June 22, 2010

Comanche Peak Nuclear Power Plant, Units 3 & 4
COL Application

Administrative and Financial Information

Update Tracking Report

**FIGURE 1.2-1
Simplified Ownership Diagram**

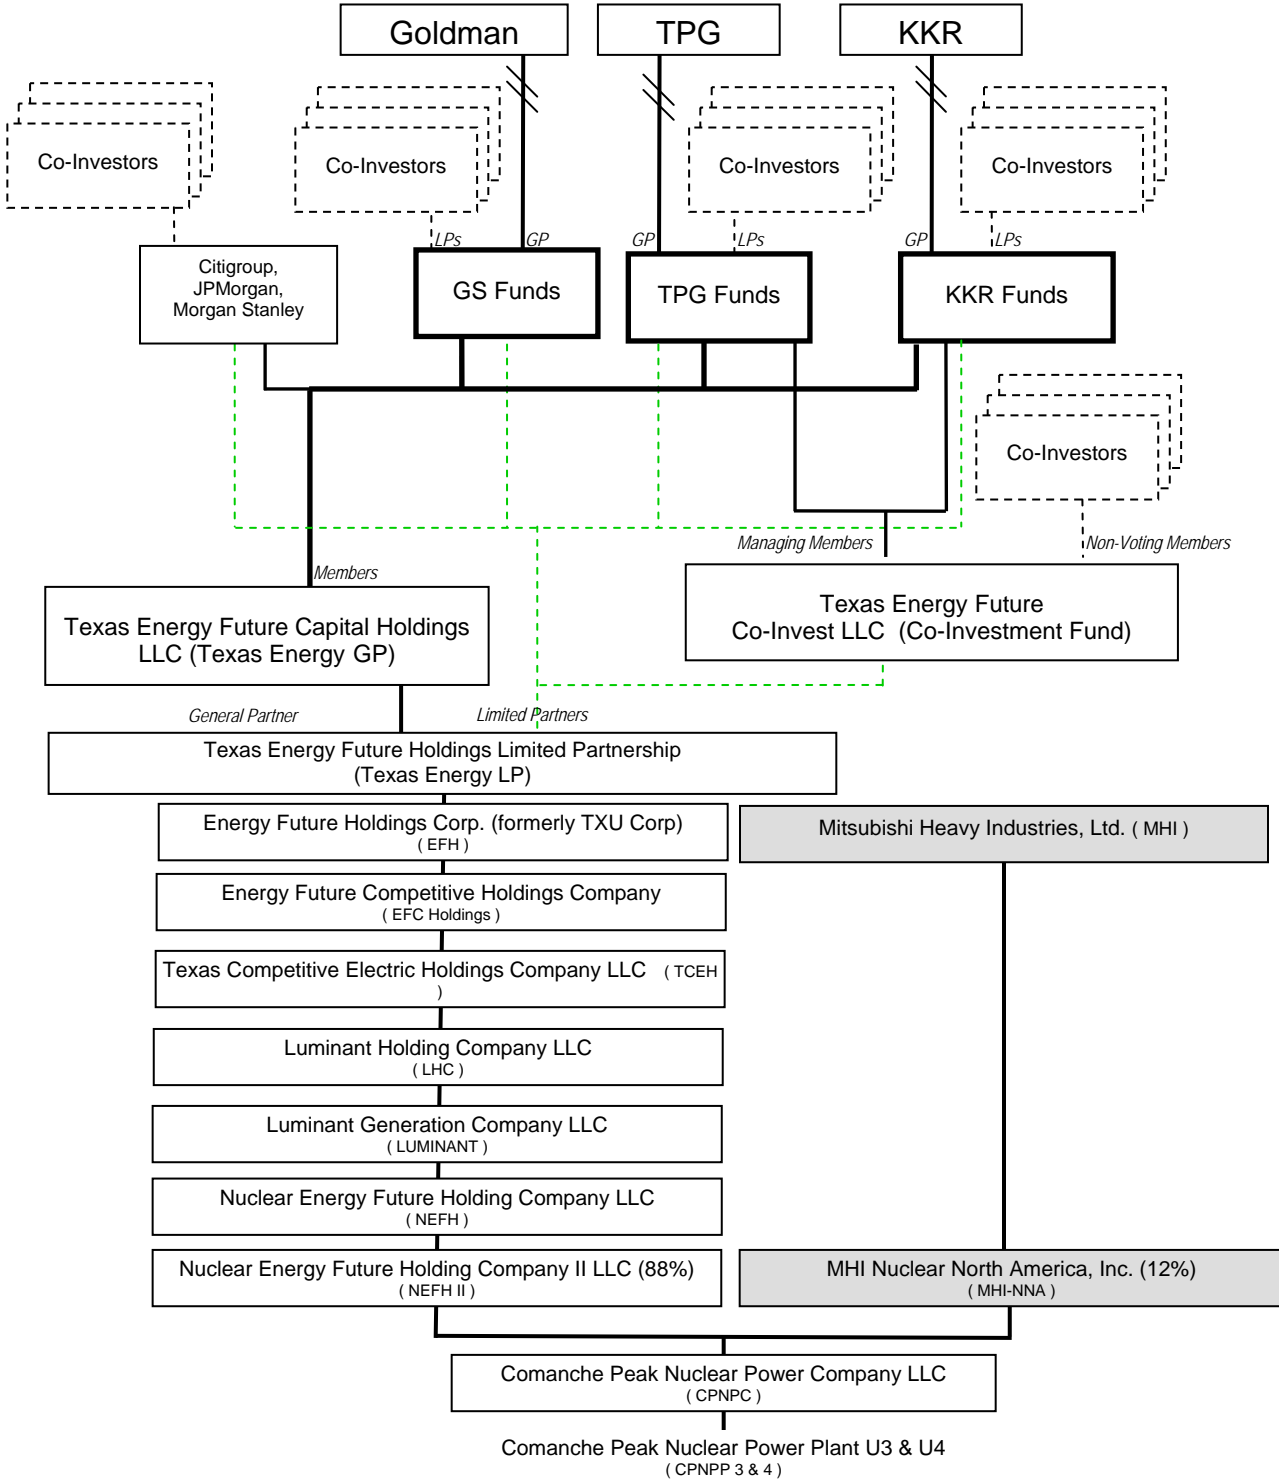
-	Figure 1.2-1	20 [23]	Update and replace Figure	Deleted Figure 1.2-1 and replace with new Figure 1.2-1 that has removed Lehman Bros	0
RCOL1_03-09-10	Table 1.3-1a	34 [36]	Response to RAI No.2.a Luminant Letter No. TXNB-10043 Date 6/10/2010	Changed percent debt and equity financing	0
